9th email corresponding with pictures. At this point not sure what's going on.

Code Compliance Officer

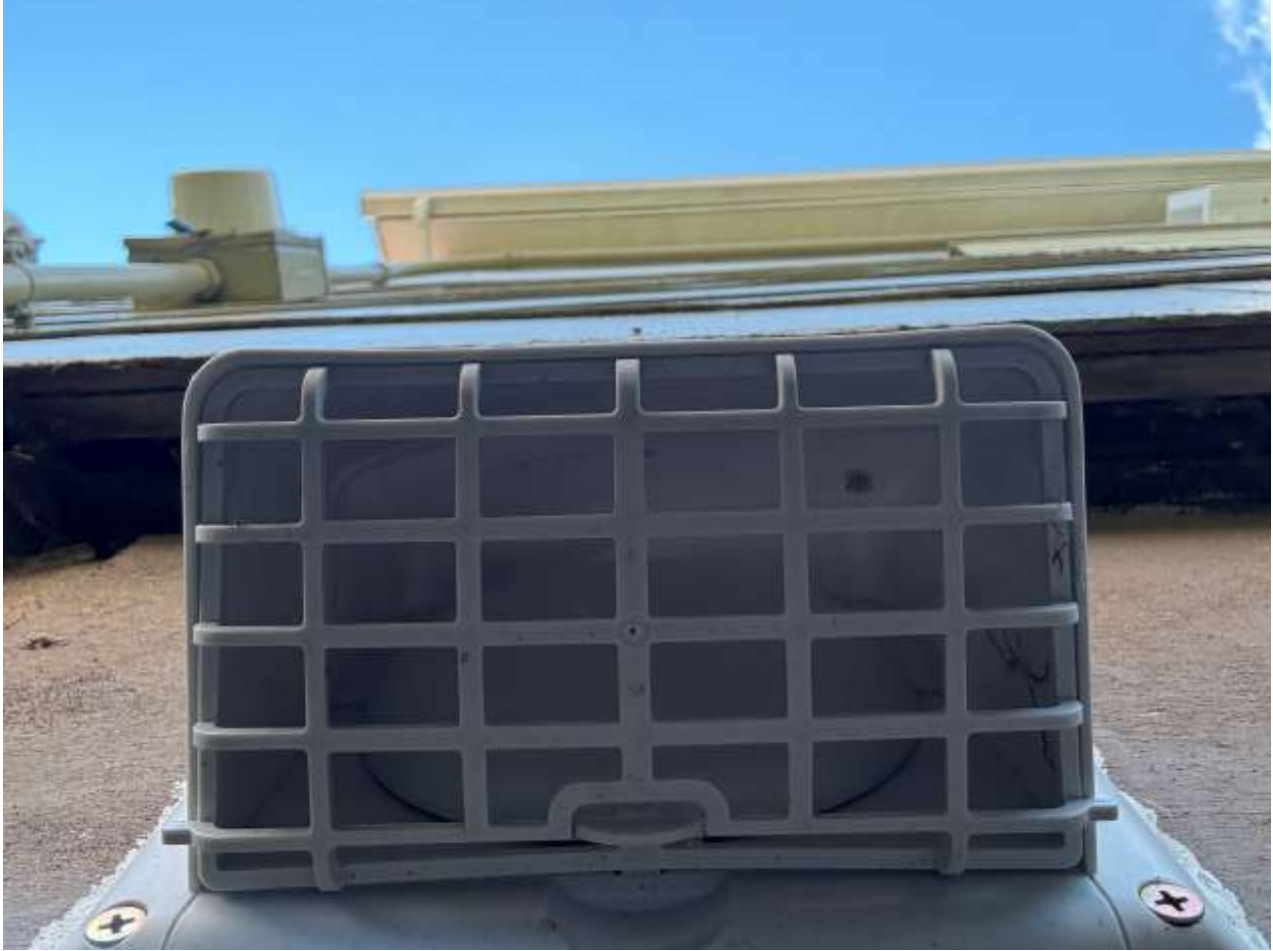
I am reaching out because the legislative team is wondering why this one is not complete. The mechanical inspector Aaron Havlicek and I left you a message some time back letting you know that you still needed to support the fresh air duct and provide a proper screen in the exterior dryer vent. The inside is sealed properly and insulated as I required, but the exterior vent with damper and bird screen is not compliant. Last time I looked at it there was just some screen stuffed up inside the existing vent cover. You will need a new vent cover with damper and ¼”x1/4” bird screen. If you have questions about the type and minimum spacing between supports for the fresh air duct, you may ask Aaron whom I’ve CC’d here. When this is done and inspected, Aaron will sign off on the mechanical and I can then issue the certificate of code compliance. Until then occupancy is still not allowed.
